DEPARTMENT OF LABOR

29 CFR Parts 1910 and 1926

Electric Power Generation, Transmission, and Distribution; Electrical Protective Equipment; Corrections

ACTION: Correcting amendments.

**Appendix A-2 to §1910.269— Application of §1910.269 and Subpart S of this Part to
Electrical Safety-Related Work Practices¹**

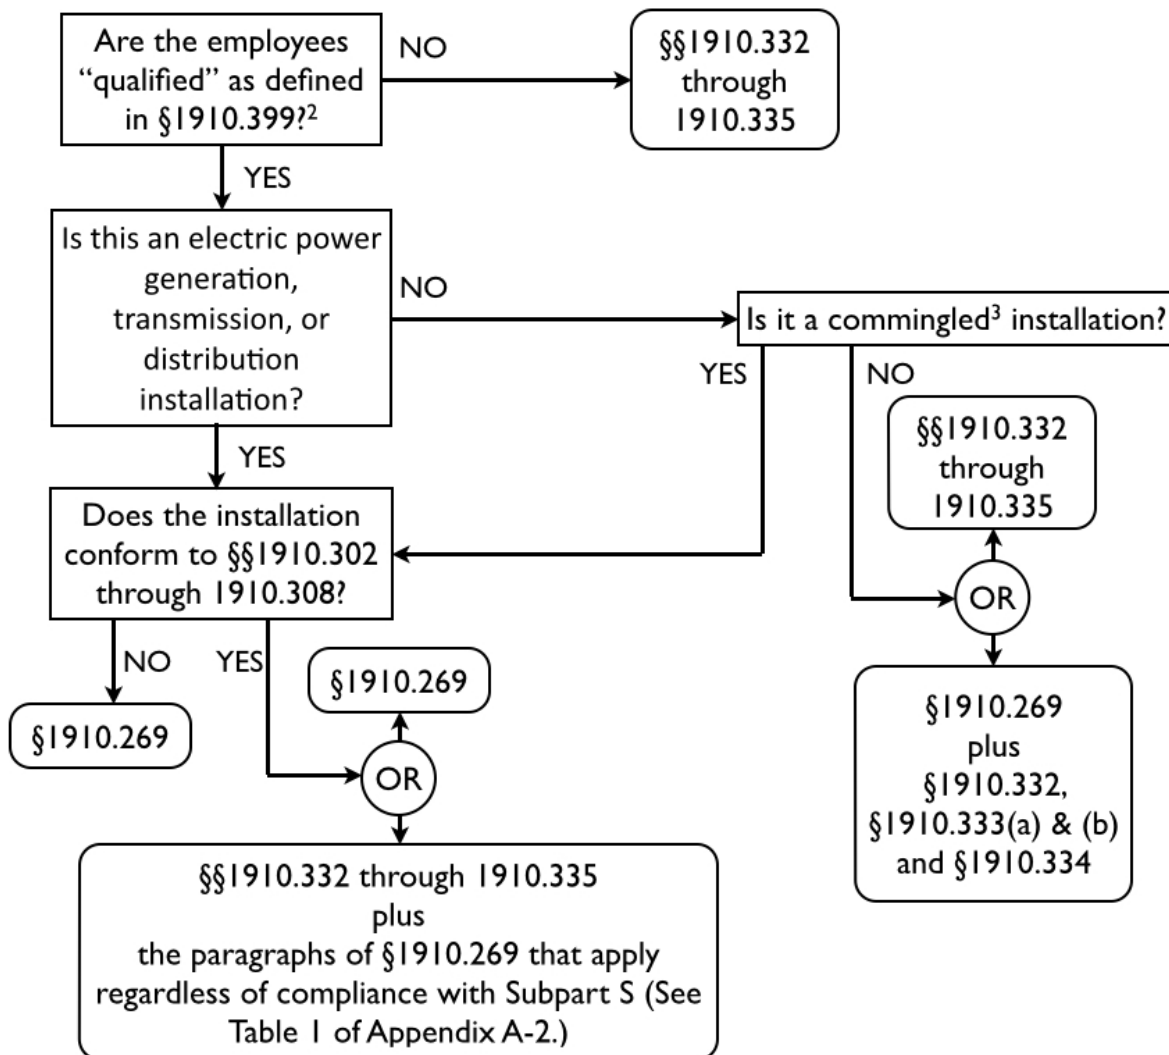
In addition, Appendix A-2 to final §1910.269 inaccurately describes how to determine whether §1910.269 or subpart S of part 1910 contains the applicable requirements for electrical safety-related work practices. The flow chart in that appendix asks whether the employee is qualified “as defined in §1910.269(x).” In subpart V, final §1926.950(a)(1)(ii) states explicitly

that subpart V does not apply to electrical safety-related work practices for unqualified employees. Thus, for the purposes of subpart V, if a worker is not a qualified employee as defined in §1926.968, subpart V does not address the electrical safety-related work practices that employee must use. However, the exemption in final (and the previous version of) §1910.269(a)(1)(ii)(B) is less direct, excluding electrical safety-related work practices covered by subpart S of part 1910. In subpart S, §1910.331(b) provides that §§1910.332 through 1910.335, which address training, selection and use of work practices, use of equipment, and safeguards for personnel protection, apply to work performed by unqualified persons on, near, or with electric power generation, transmission, or distribution installations. Consequently, the electrical safety-related work practices for employees who are not qualified persons (employees) as that term is defined in subpart S (§1910.399) are in subpart S, not §1910.269. However, §1910.269 does apply to electrical safety-related work practices for employees who are qualified under subpart S, but not qualified under §1910.269.¹ This class of employee includes, in particular, line-clearance tree trimmers, as explained in the preamble to the 1994 final rule adopting the previous version of §1910.269 (59 FR 4320, 4336, 4409 – 4410, Jan. 31, 1994). For this reason, OSHA is correcting the first question in the flow chart in Appendix A-2 to §1910.269 so that it refers to the definition of “qualified” in §1910.399 instead of the definition of that term in §1910.269(x).

d. Revise Appendix A-2 to §1910.269;

¹ This flowchart applies only to the electrical safety-related work practice and training requirements in §1910.269 and §§1910.332 through 1910.335.

² See §§1910.269(a)(1)(ii)(B) and 1910.331(b) and (c)(1).

³ This means commingled to the extent that the electric power generation, transmission, or distribution installation poses the greater hazard.
